Addendum No. 5

Date: April 26, 2013

Reference: Regional Training Institute – TASS Phase 2
Utah National Guard – Camp Williams, Utah
DFCM Project No. 11020480

Subject: **Addendum No. 5**

1 LEVEL 1 LIGHTING PLAN
EL101 1/8" = 1'-0"

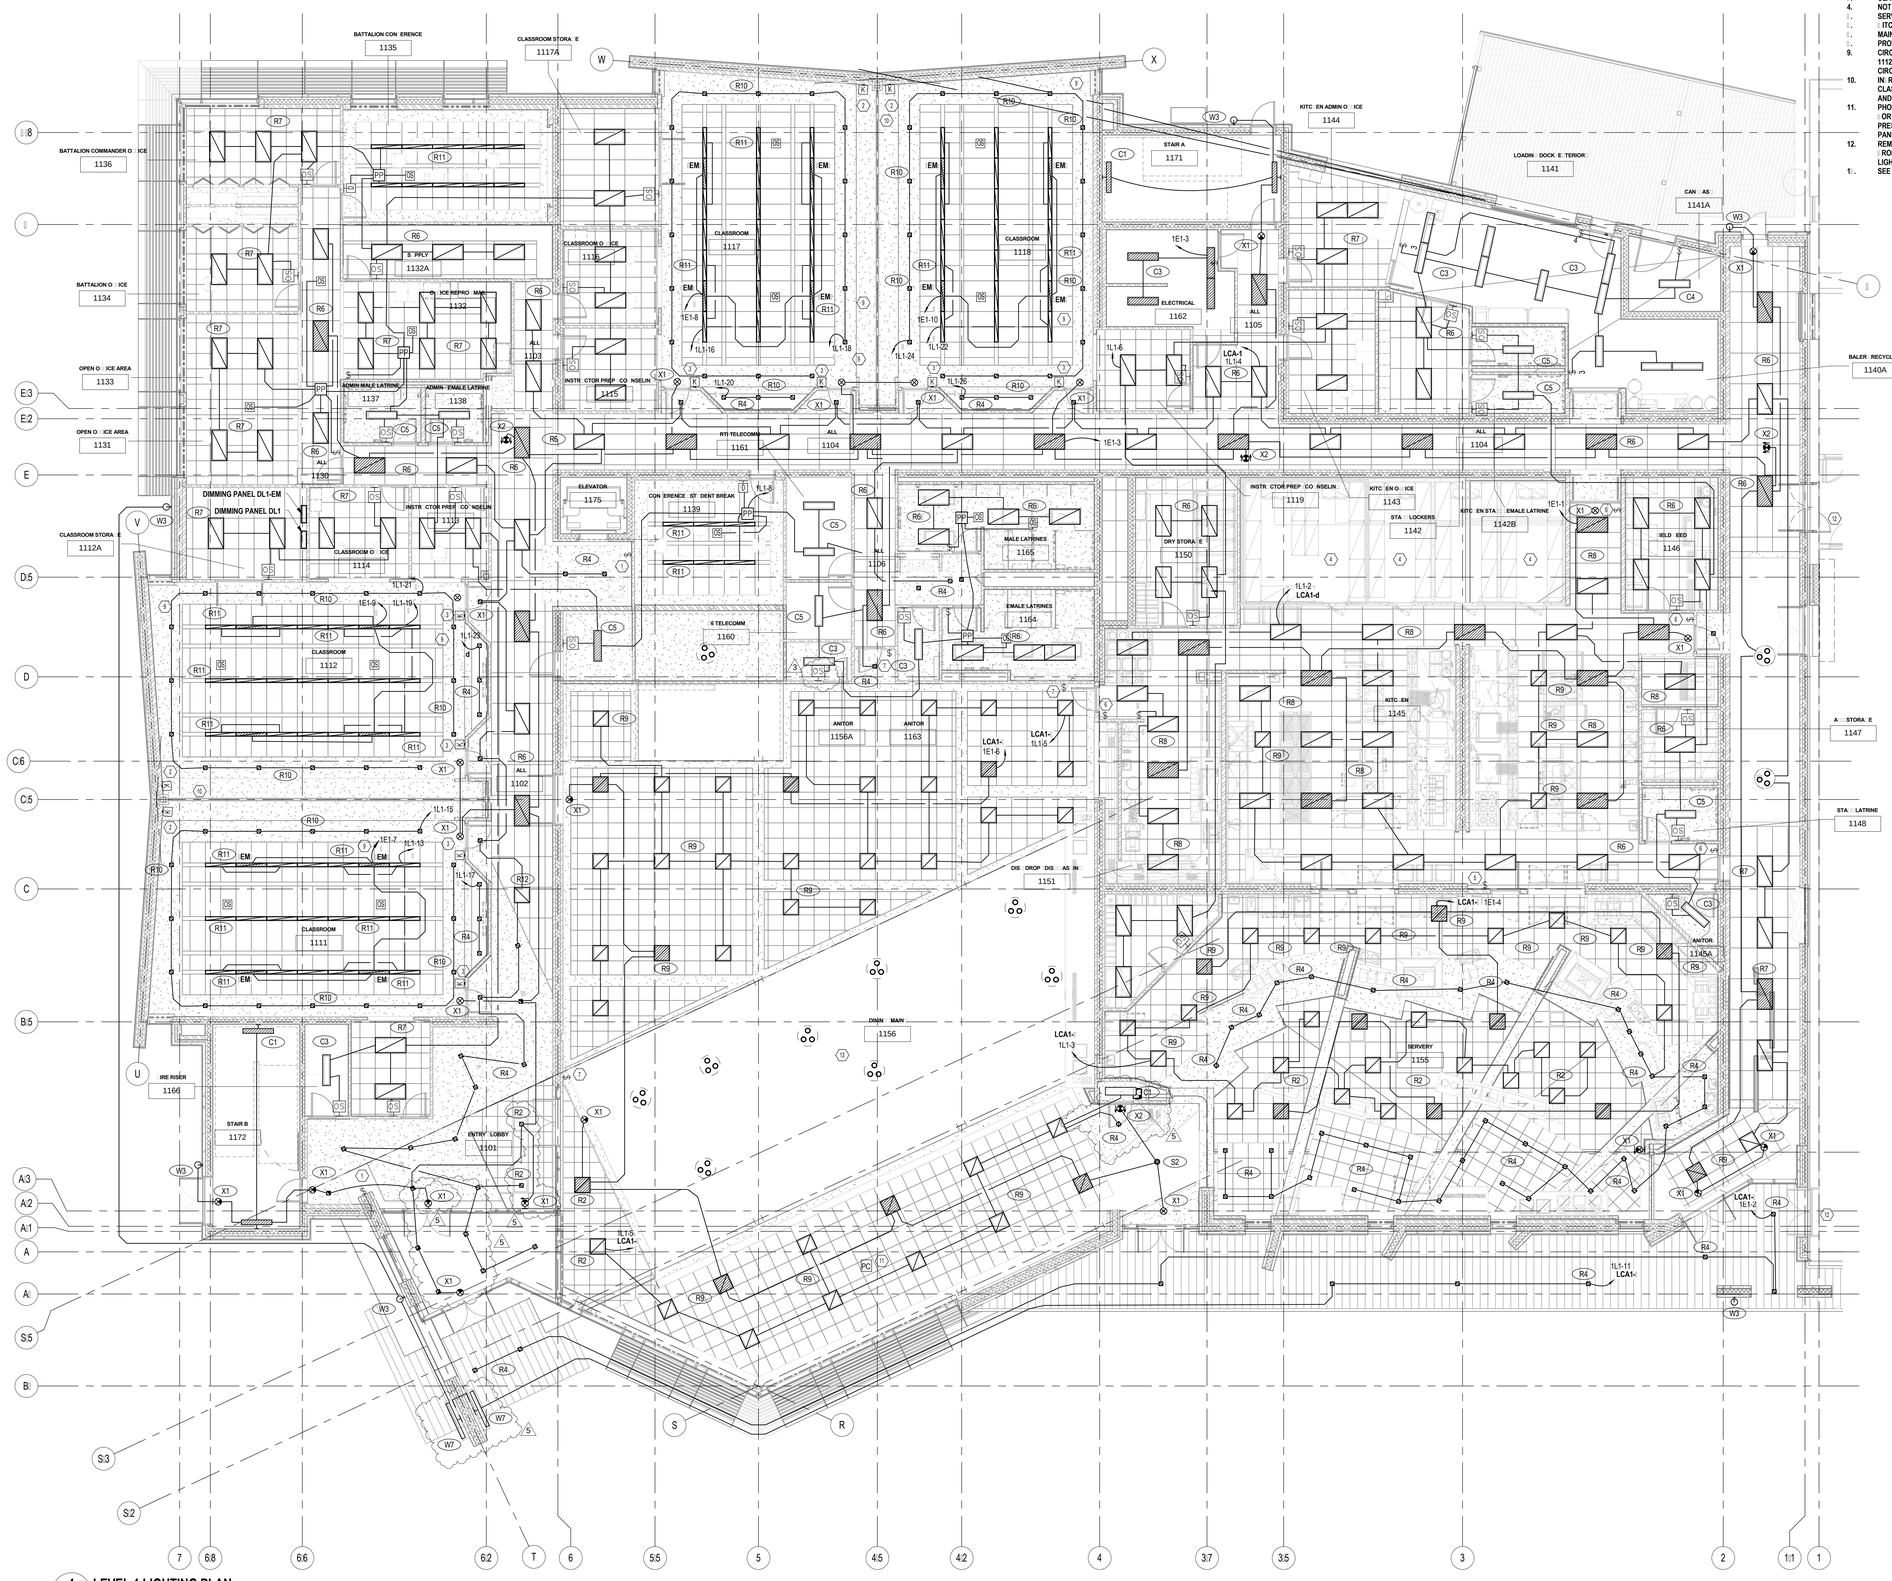
46. Sheet EL101: Note 4 indicates not used yet shows up in freezers?
    a. ***See the attached Memorandum from Engineer, dated April 25, 2013.***

E: ED NOTES - SHEET A-EV101

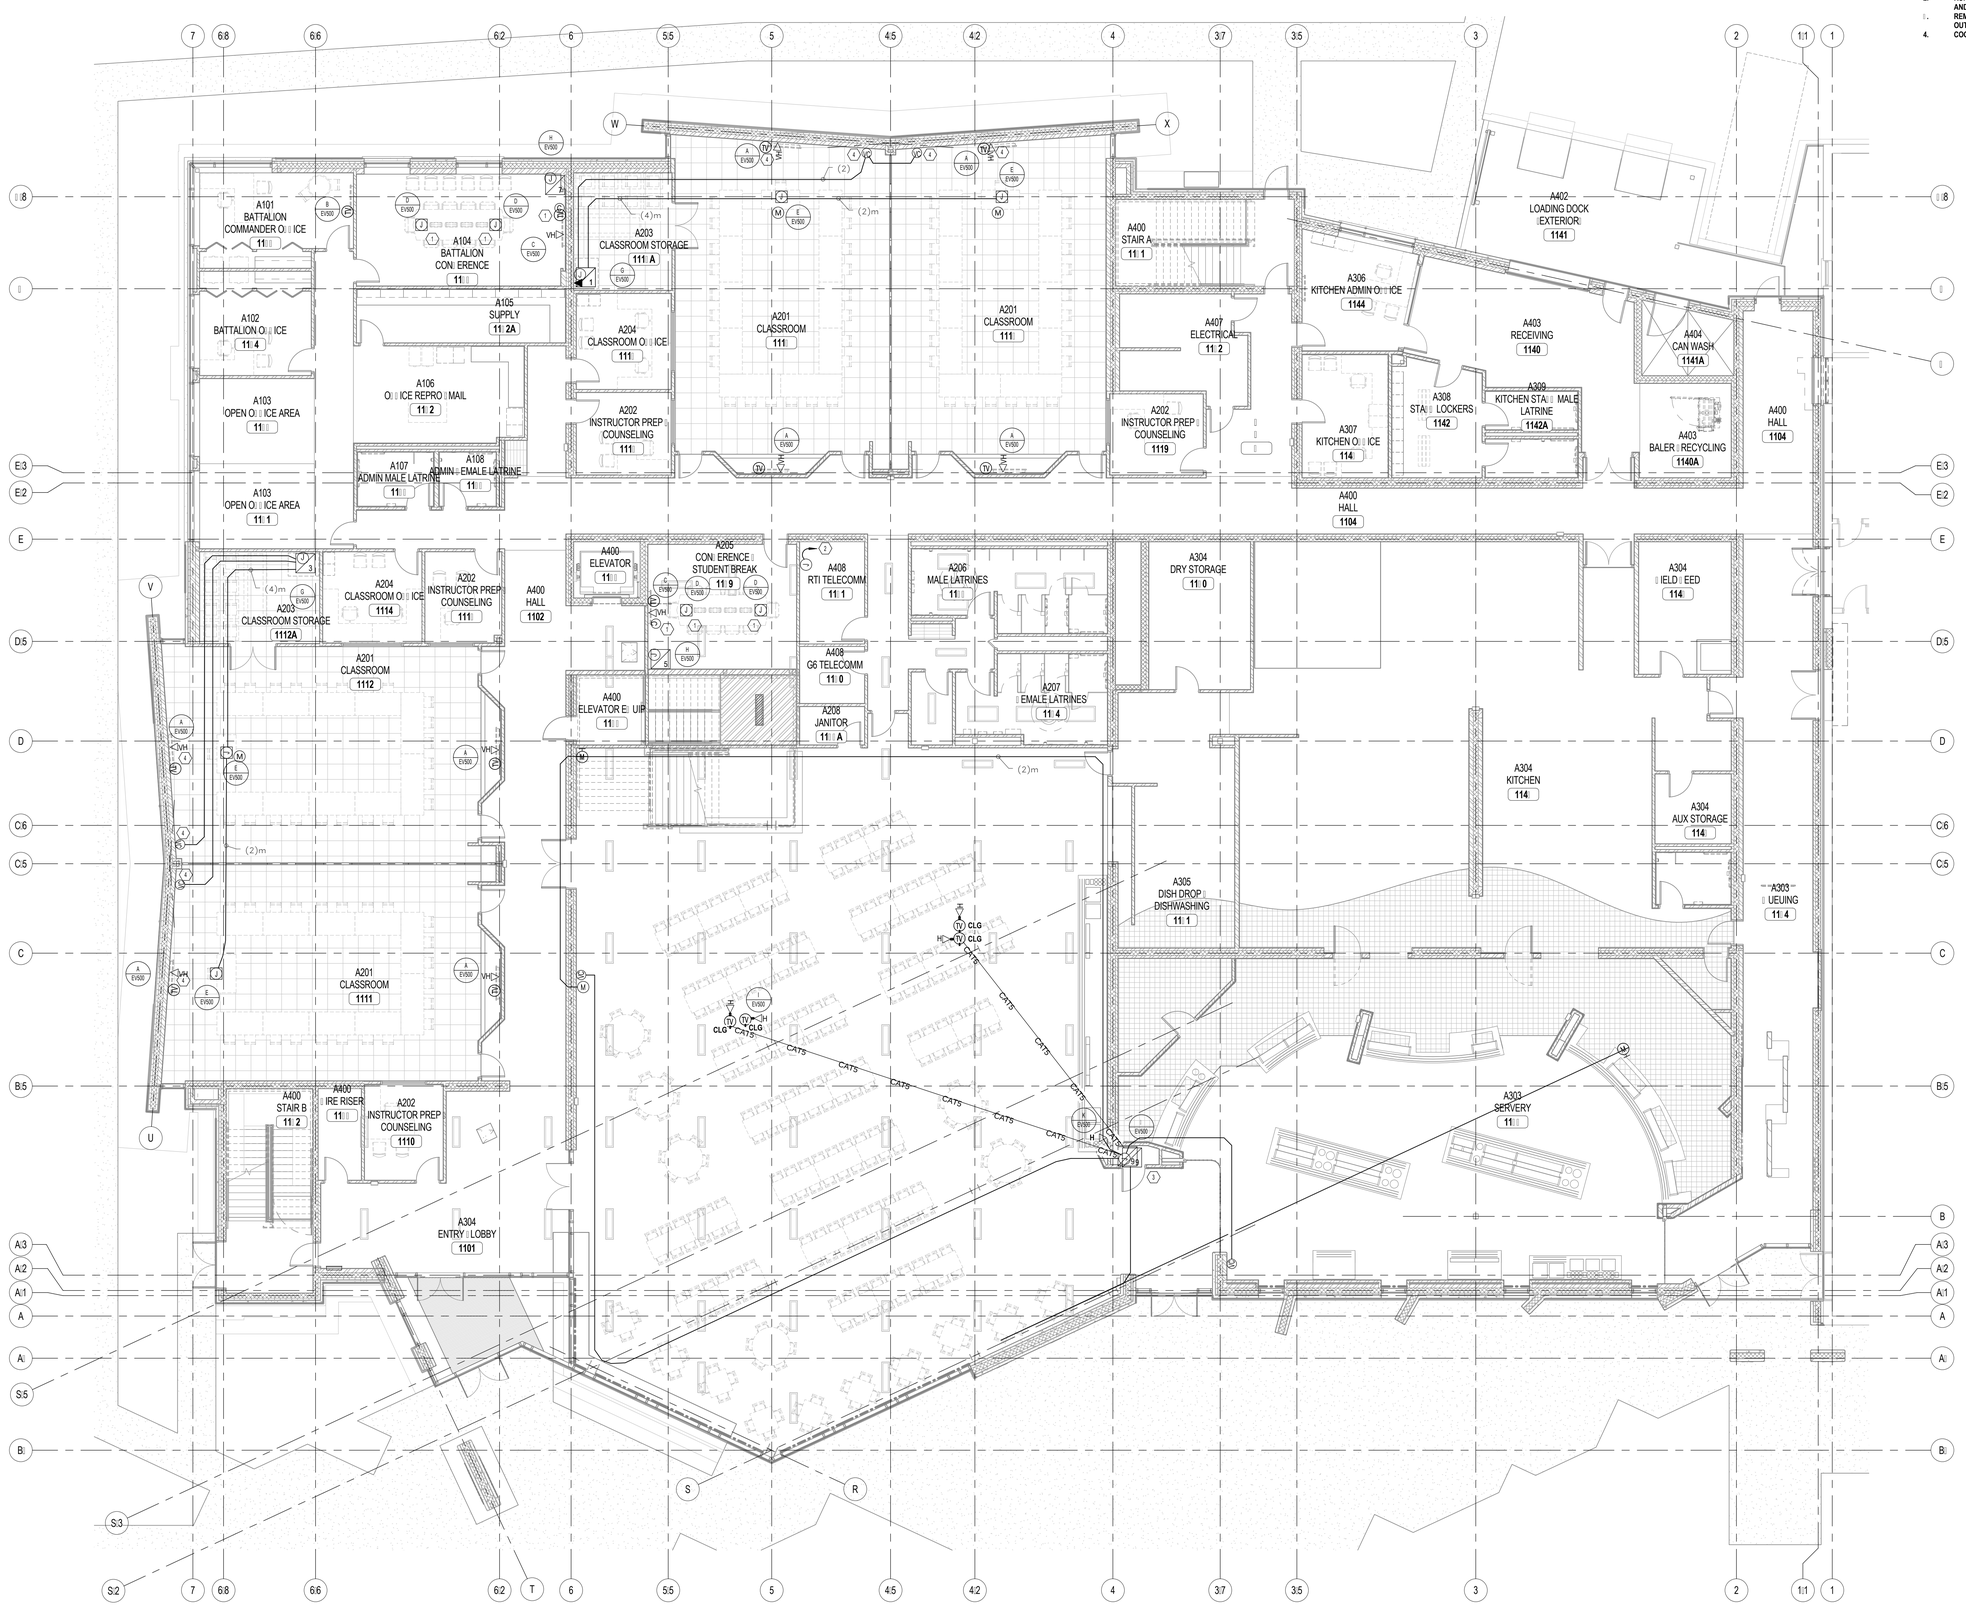
47. Sheet EV101: Adjacent the sound cabinet #9 there is a detail call out for K on EV500, Detail is not on EV500?
    a. ***See the attached Memorandum from Engineer, dated April 25, 2013.***

48. Sheet EV101: Note 2 says “requirements” what does it mean.
    a. ***See the attached Memorandum from Engineer, dated April 25, 2013.***

Sheet EV101
40. Clarification. Note 2 should read, “RUN ONE RG11 CABLE FROM THE JUNCTION BOX TO MAIN AMPLIFIER AND SPLITTER.”

J TV OUTPUT ON COLUMN

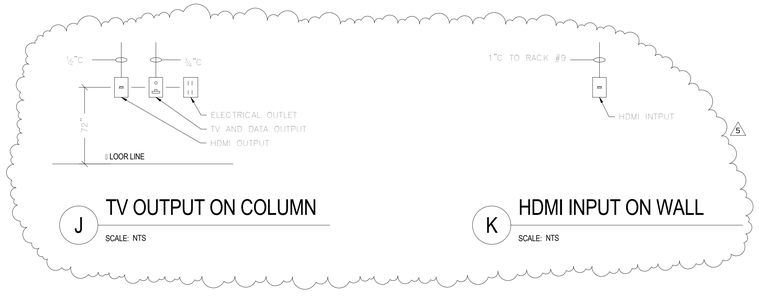
Sheet EV500
45. Add details J and K as shown on attached sheet EV500

KEYED NOTES – SHEET A-EJ101

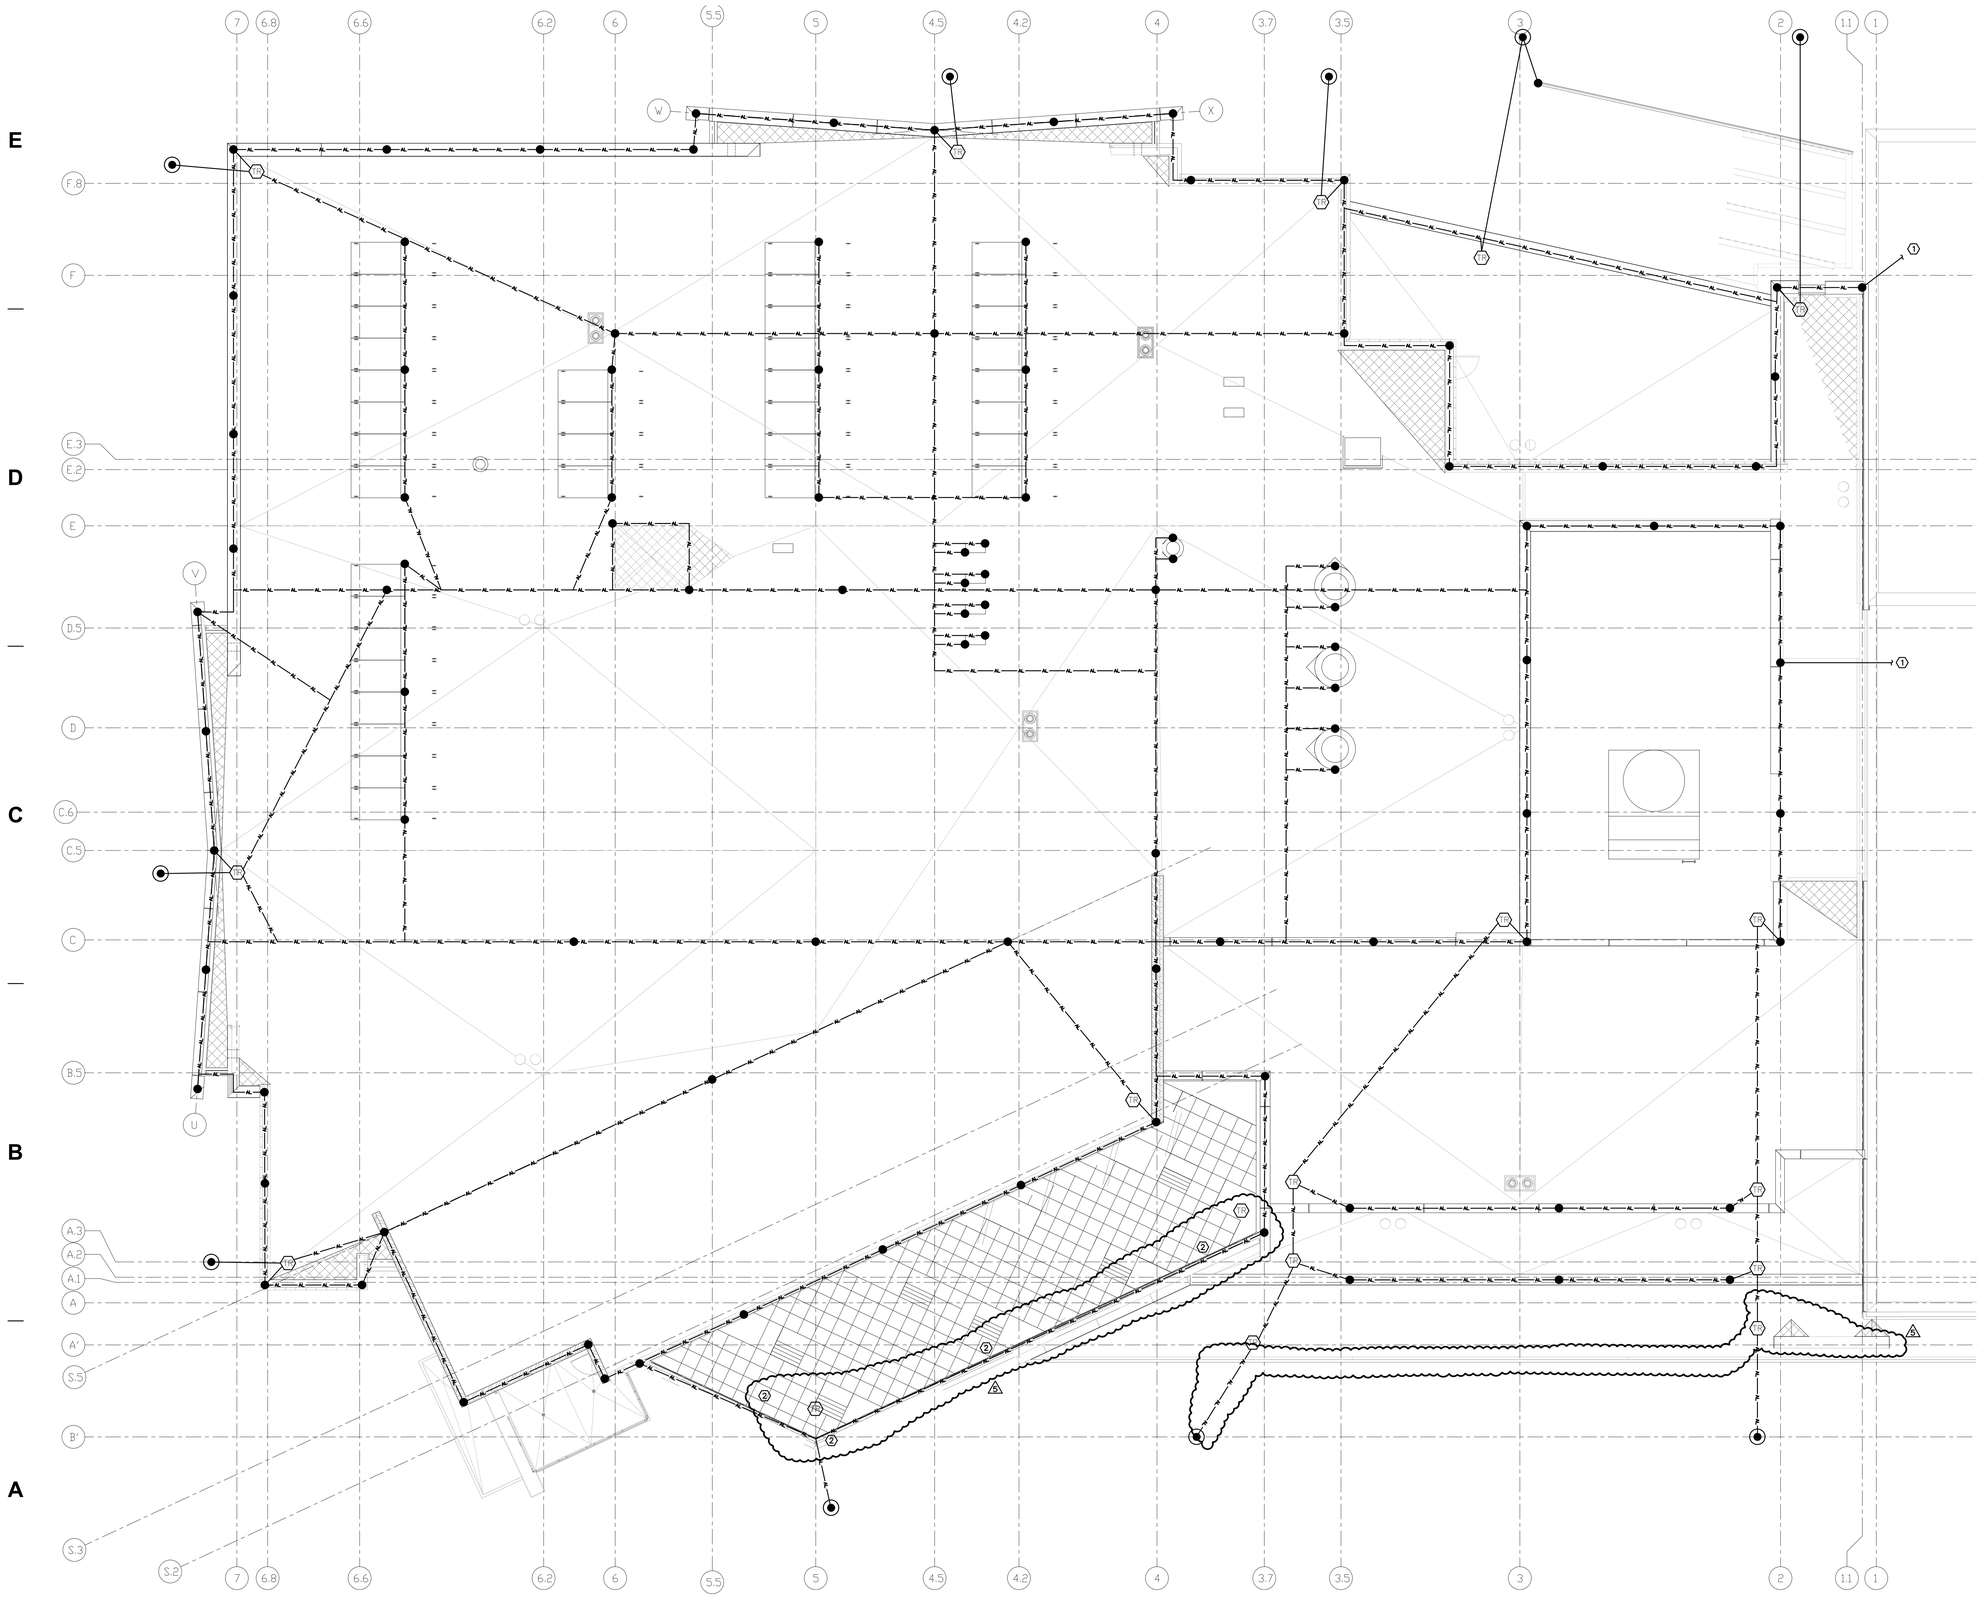
Sheet EJ101
46. Delete the (3) lightning rods on the railing (grid line 5,B diagonally to grid 4, A) It is confirmed that the rail has a wall thickness of greater than 3/16”. Bond the lighting protection system to that railing.
47. Add keyed note #2 stating, “BOND GUARD RAIL OF BALCONY TO LIGHTNING PROTECTION SYSTEM”
